Doubletree Resort Development Plan/ Coastal Development Permit Modifications

Final Supplemental Environmental Impact Report

March 2003

Figure 3-1

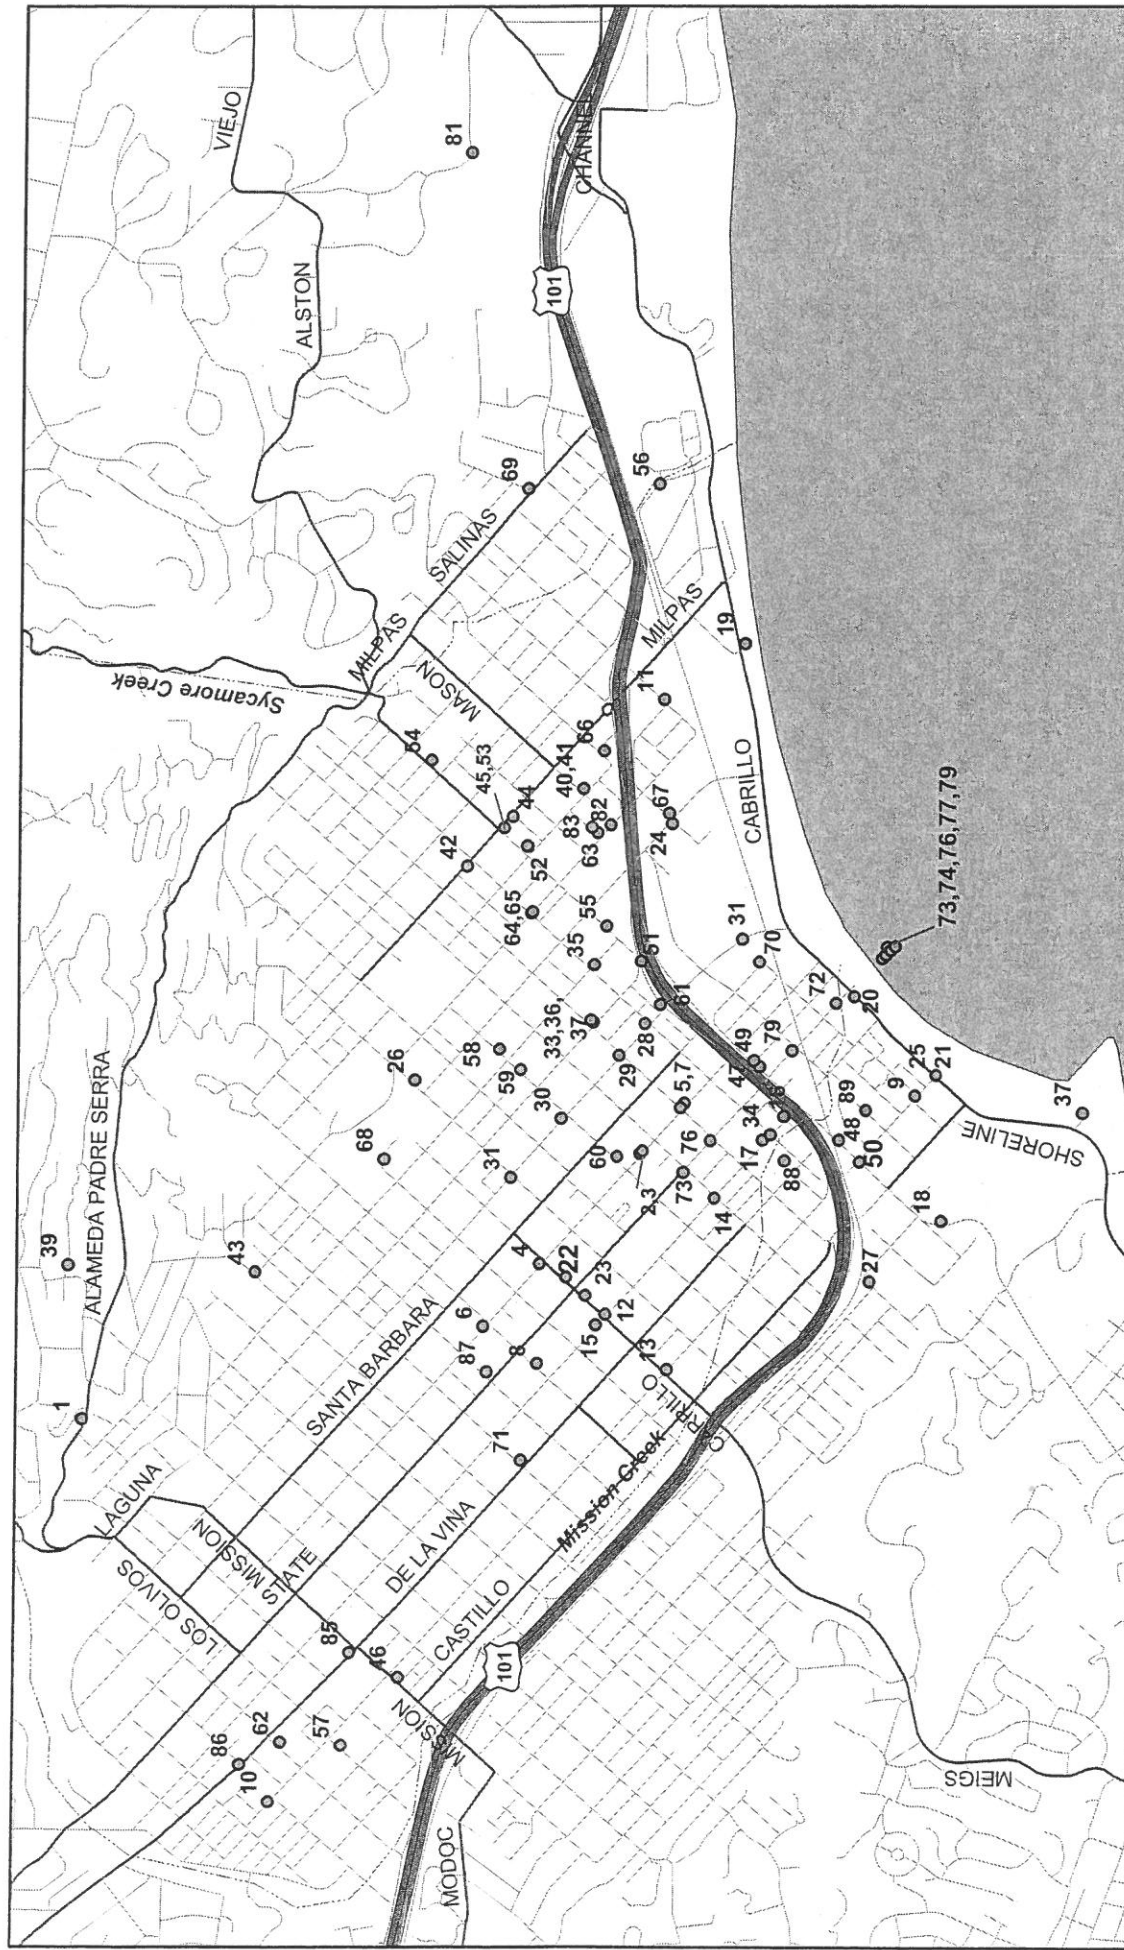
Figure 3-1
added
per
Comment
5C.

The commentor suggests adding a map showing the locations of planned and pending projects in the area. In response to this comment, a new figure (Figure 3-1) will be added to the Final EIR. Please see the attached figure.

Figure 2-2

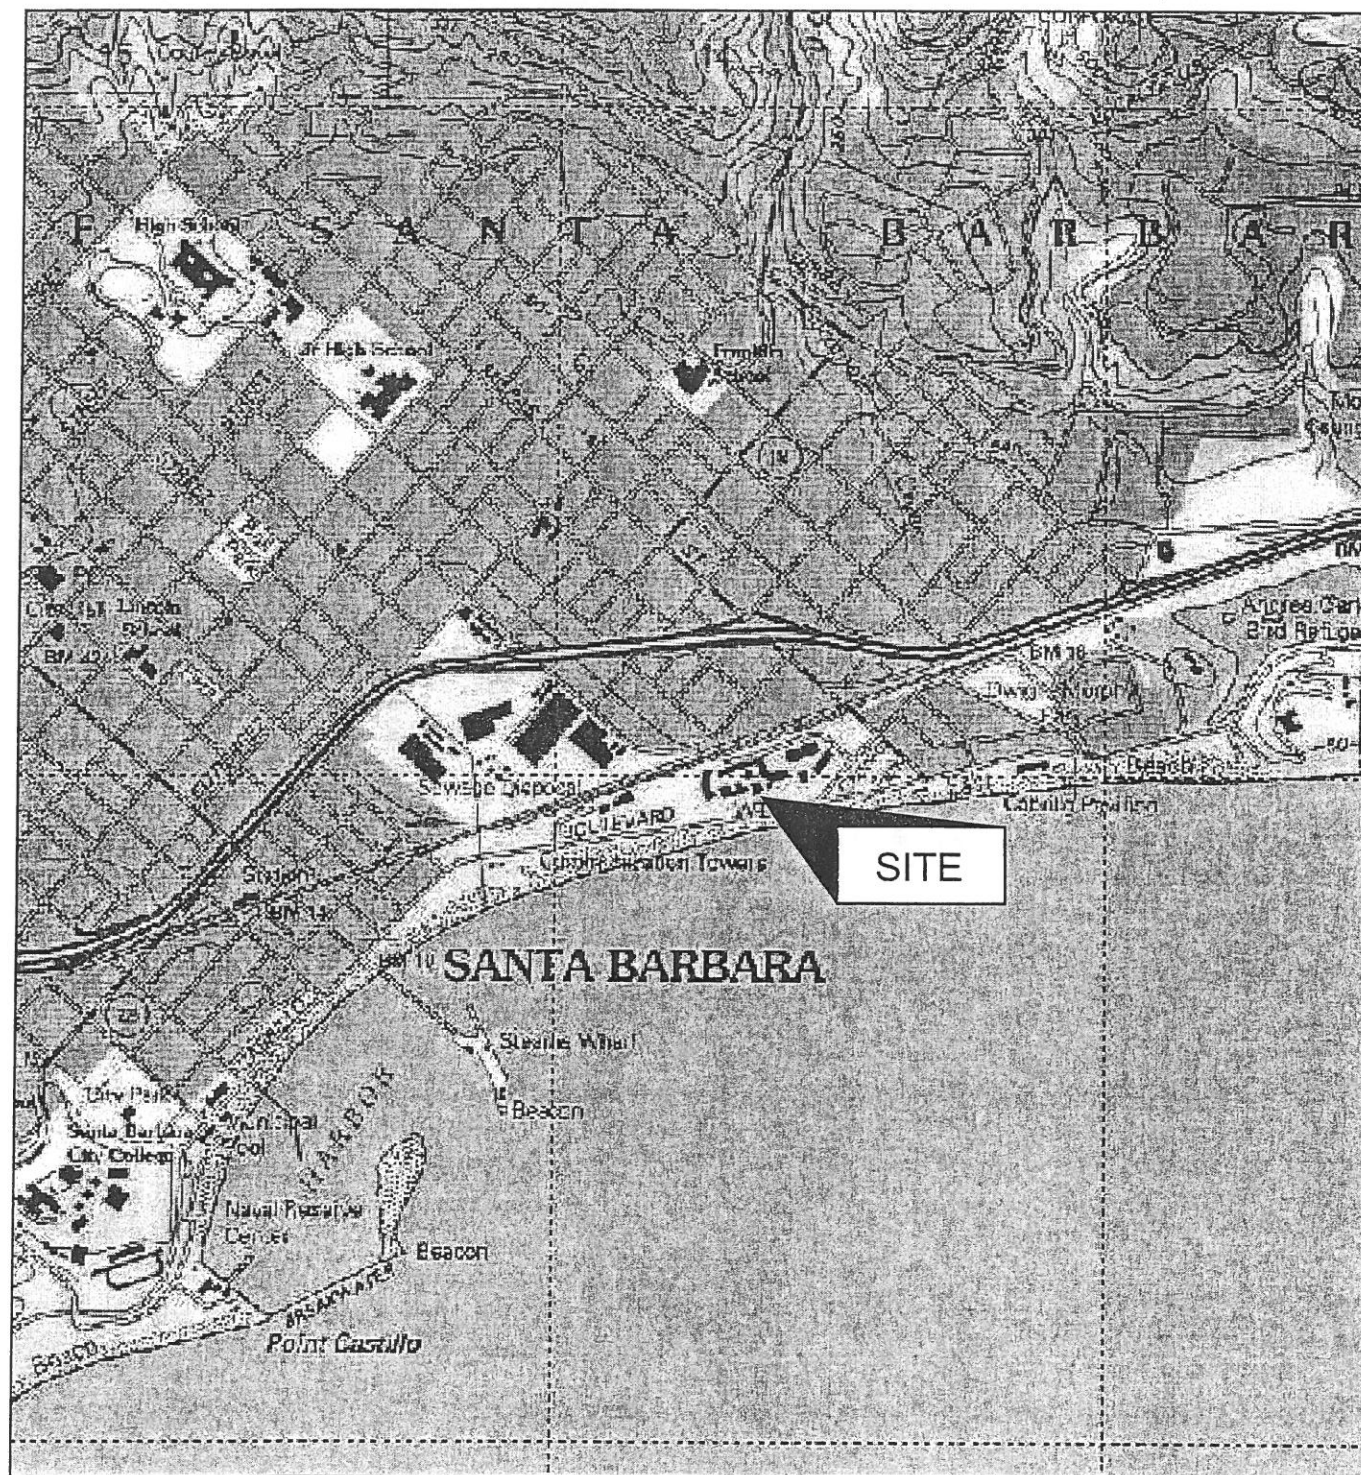
Comment 1. Figure 2-2. (p. 2-3)

Figure 2-2's resolution makes it difficult to read and the site box obstructs the reader's view of a portion of the impacted area. Figure 2-2 would be more useful if it could be cosmetically improved.

The commentor suggests changes to Figure 2-2. In response to this comment, Figure 2-2 has been modified to improve its clarity (see attached).
